TECHNICAL MEMORANDUM

Reference No. PS139771-001-TM-Rev0

AMITY FLOW SLIDE BARRIER – GEOPHYSICAL SURVEY COMMENTS AND UPDATES

COMPARISON ROCK ARMOUR CROSS SECTIONS SHEET 4
OF 4

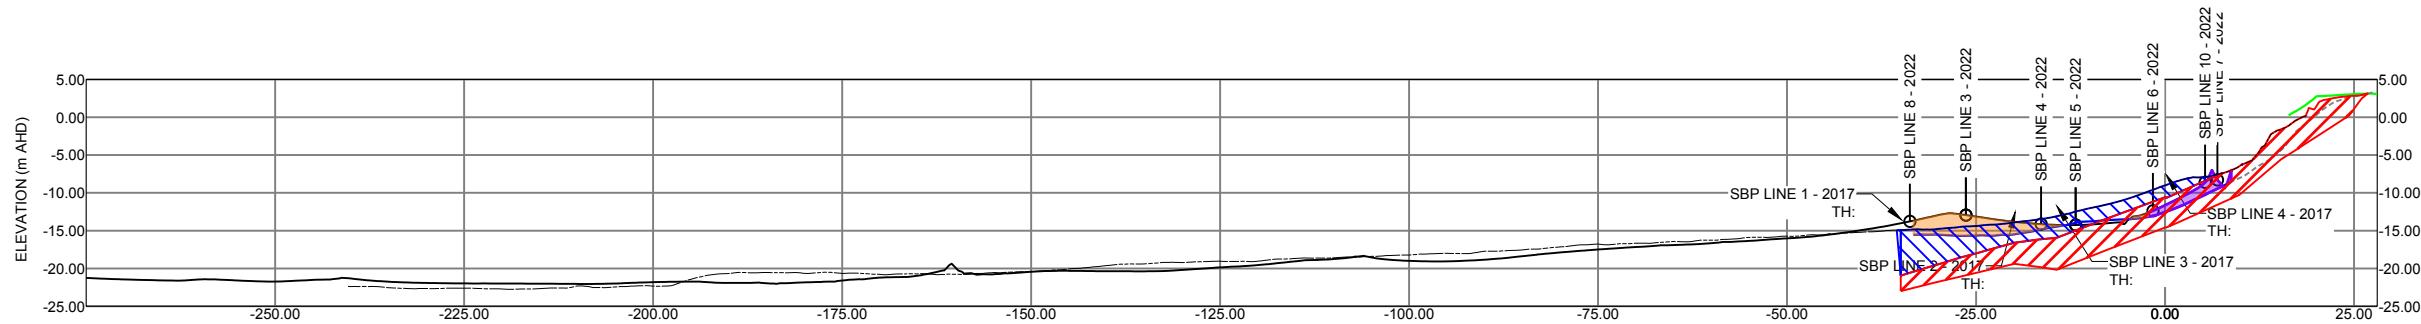
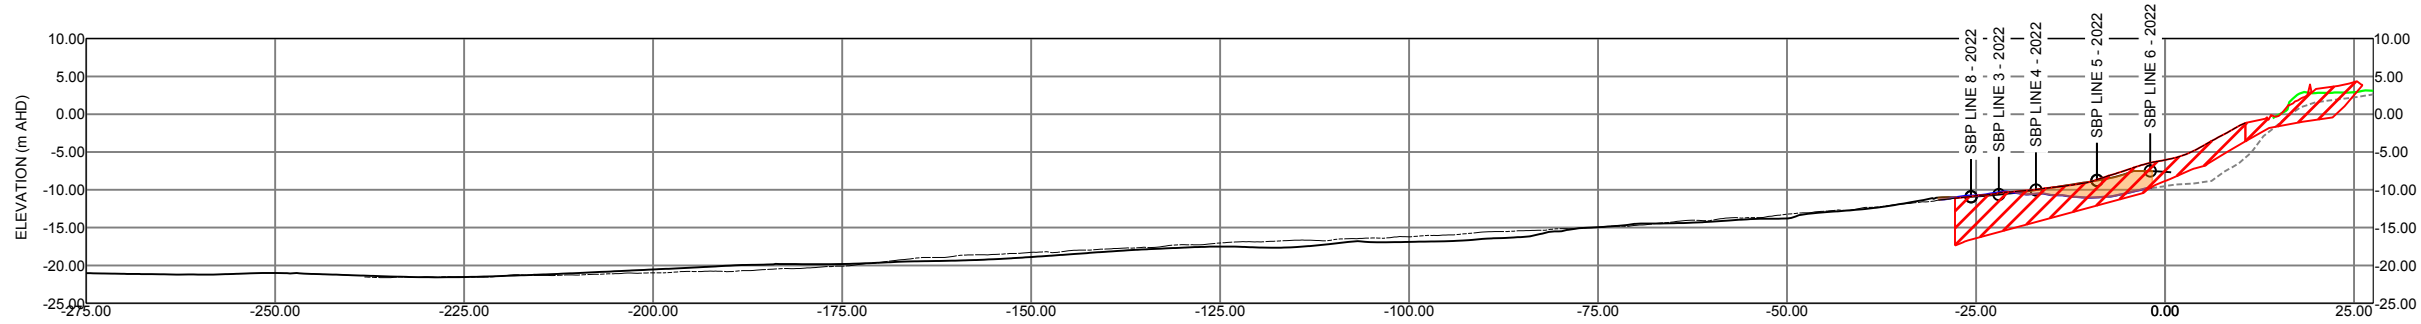
A review of the comparison cross-sections provided in Figures B2 to B5 shows the extents of the interpreted predominantly boulder material to be reduced in comparison to the 2017 survey. This may be in part due to the 2022 survey equipment and data processing identifying these areas more accurately and better delineating between the predominantly boulder material and the mixed sand and boulder materials. The thickness of the predominantly boulder material is also generally reduced in the 2022 survey results, with the exception of the sections at CH 700, CH 750, CH 850, CH 900, and CH 1100 which show comparable or greater thickness of this layer in the 2022 survey.

The Water Technology report indicates cross-section results at CH 1000, 1250, and 1450 failed to detect a noticeable toe or interpreted boulder material. This is generally correct for the 2022 survey, however it is noted that some interpreted boulder material was observed at these locations in the 2017 survey.
